Service Letter #: SL05-56-15145

Part/Assembly #: 56-15145/56-15170 Tie Rod Fitting [Inspection & Replacement of]

Float Model Affected: Aerocet Model 5850 Twin Seaplane Float installation on DeHavilland DHC-2 "Beaver" (All)

Figure 1 - Showing lower tie rod installation
(Reference Service Manual, Parts Catalog, Figure 17)

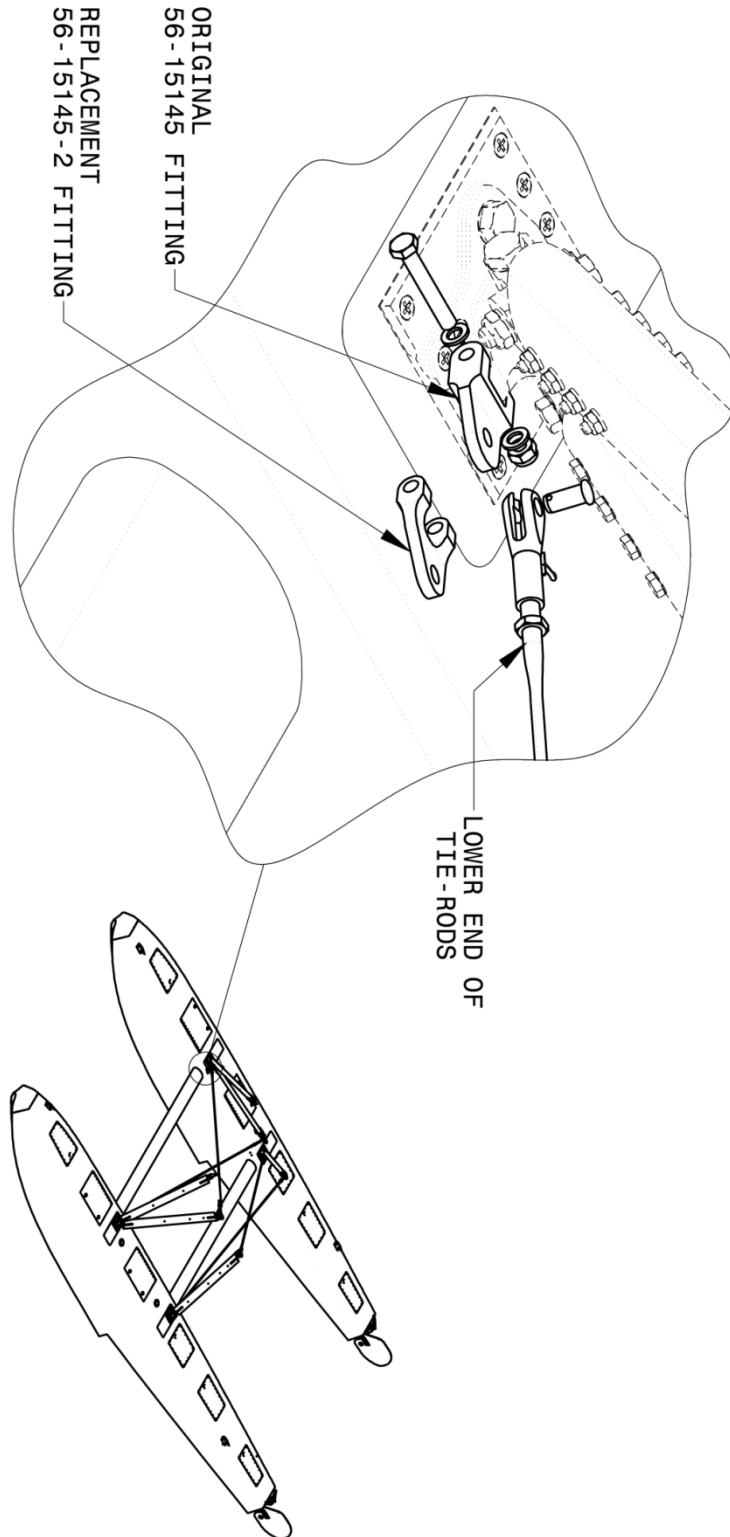
During next regular inspection per Aerocet Service Manual, A-10034, Rev 1 or later, include partial disassembly of the lower ends of the tie rods at the Aerocet fittings for all tie rods (crossing wires). Particular attention should be focused beneath the tie rod clevises for indications of corrosion. Parts exhibiting corrosion should be replaced.

Original 56-15145 (now designated with a "-1") is easily identified as painted aluminum. Replacement part, 56-15145-2, is constructed from corrosion resistant steel (stainless), not painted.
